IMPORTANT SAFETY RECALL

Re: Safety Recall – Smart-Steer 2.0 Self-Steer Axle with 702887 Steer Arm

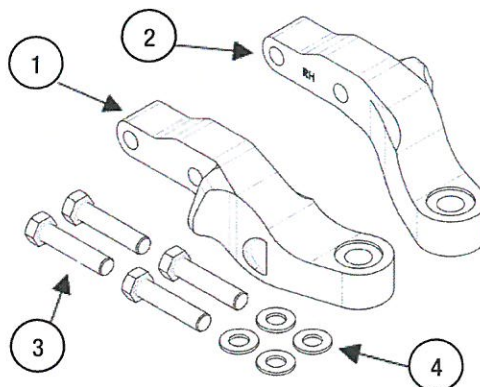
Replacement steer arm kit for these models is 703294-01 and contains:

Item Number	Quantity	Part Number	Description
1	1	703293-LH	B/O steer arm LH
2	1	703293-RH	B/O steer arm RH
3	4	703100	BOLT 3/4-16UNF 3.25"lg GR8 Yellow Zinc (VMI)
4	4	701810	WASHER FLAT .75" MC2 GR8 (VMI)
Not shown	1	0150425	LOCTITE®, BLUE 242, 0.5ml

Steer Arm Welding Specifications

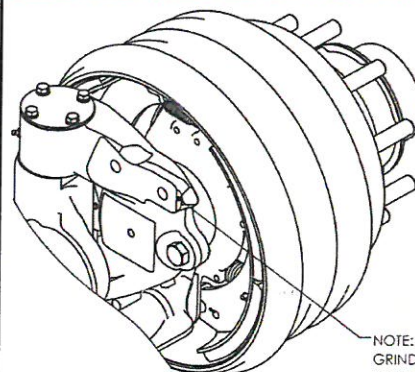
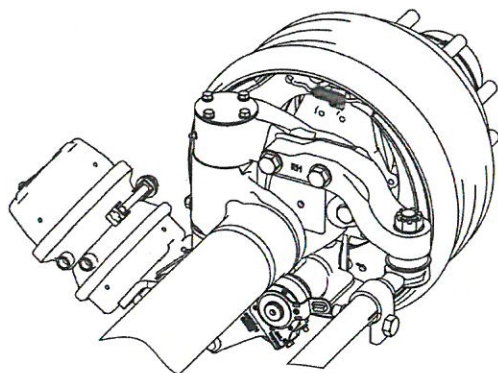
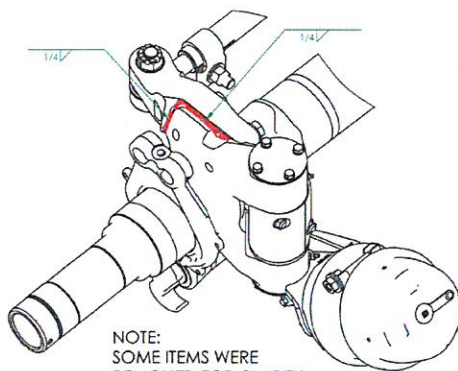
NOTE:
GRIND 3/16" X 45° CHAMFER
BEFORE INSTALLING STEER ARM
